PLANNING REPORT

Administrative Review Team

Veterinary Emergency Group Signs 22-114MPR

Existing Ground Sign at Sawmill Road (View to the North)

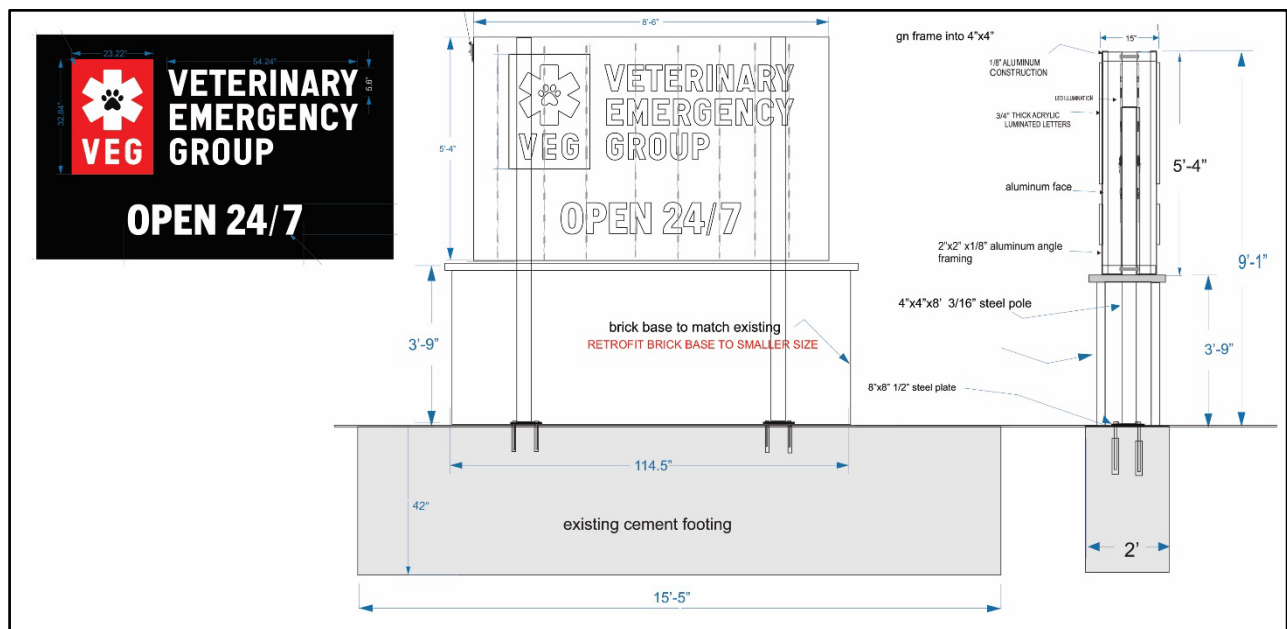
The existing sign bases are constructed of the same brick as the existing building and are legally non-conforming in their current location based on expansions of the adjacent Sawmill Road and Dublin Center Drive rights-of-way (ROW) in the years since the site was developed in 1987. Based on aerial imagery, it appears that the Sawmill Road sign encroaches the ROW by approximately 2 feet, and that the Dublin Center Drive sign is setback approximately 2.75 feet from the ROW, less than the 8 feet required by Code.

While continuing to utilize the existing sign foundations, the existing bases are proposed to be retrofitted to a reduced length to better correspond to the proportions of the proposed new signs. The Sawmill Road sign base is proposed to be reduced from the existing length of 13 feet to 9.53 feet, and the Dublin Center Drive sign base reduced in length from 7.67 feet to 6.33 feet. Both sign bases are proposed to replace the existing 4-inch cast limestone cap with a 2-inch bluestone cap. The sign base length modifications must be implemented such that the

existing ROW encroachment at Sawmill Road is eliminated, and that both signs be brought closer to compliance with required setbacks. To verify that any encroachments into the ROW have been resolved, the applicant shall provide an as-built professional survey for review by Engineering, following the proposed retrofit of the sign bases. To ensure that the sign bases maintain a consistent appearance and match the building, the existing brick be salvaged and reutilized in the reconstruction of the modified portions of the sign base, and that any new brick proposed be subject to Planning approval prior to submitting for sign permits.

- 1) That the applicant provide a professional survey of the as-built site conditions following the proposed retrofit of the sign bases for review by Engineering in order to verify that no encroachments into the rights-of-way exist;

- 2) That the sign bases maintain a consistent appearance and match the building, the existing brick be salvaged and reutilized in the reconstruction of the modified portions of the sign base, and that any new brick proposed be subject to Planning approval prior to submitting for sign permits;

Proposed Ground Sign at Sawmill Road

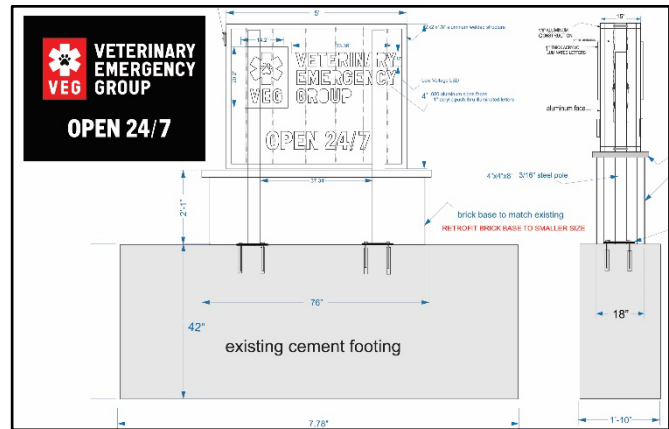
The proposed sign faces vary in size but feature a consistent design. The Sawmill Road sign face is eight and one-half feet wide by five-foot four inches tall, or 45.33 square-feet in area; and the Dublin Center Drive sign is five feet wide by four feet tall, or 20 square-feet in area. Both are within two-sided, 15-inch wide aluminum sign cabinets, internally-illuminated with LED lights.

The faces of both signs are comprised of black aluminum sign background with the business name and secondary images in acrylic pushed through the stencil cut sign background a distance of one inch. The business name "VETERINARY EMERGENCY GROUP" is in white copy justified to the right of the rectangular logo in red, white and black. Centered at the bottom of the sign is the secondary image copy "OPEN 24/7" in white. For both signs, the overall sign sizes, colors, and area of secondary images are in compliance with Code. The proposed sign faces are specified as 0.080-inch aluminum, and should be increased to the 0.125-inch aluminum thickness recommended by the Bridge Street District Sign Guidelines. No specifications have been provided for the proposed acrylic sign material. The minimum .125-inch thick Solar Grade acrylic recommended by the Sign Guidelines should be specified to avoid fading.

Landscaping is present at the bases of both existing signs in compliance with Code. With the proposed modifications to the sign bases, additional landscape material may be required to fill in gaps in the existing landscaping or to replace plant material damaged during this process. Planning recommends that additional landscaping be incorporated around the base of both signs as necessary following reconstruction of the sign bases, subject to Planning approval.

- 3) That landscaping be provided at the base of the signs where necessary to fill gaps or replace damaged plant material resulting from the proposed modifications to the sign bases; and

- 4) That the proposed sign face thickness be increased from the specified 0.080-inch aluminum, to the 0.125-inch aluminum thickness, and that the proposed acrylic sign face elements be Solar Grade with a minimum thickness of 0.125-inch as recommended by the Bridge Street District Sign Guidelines.
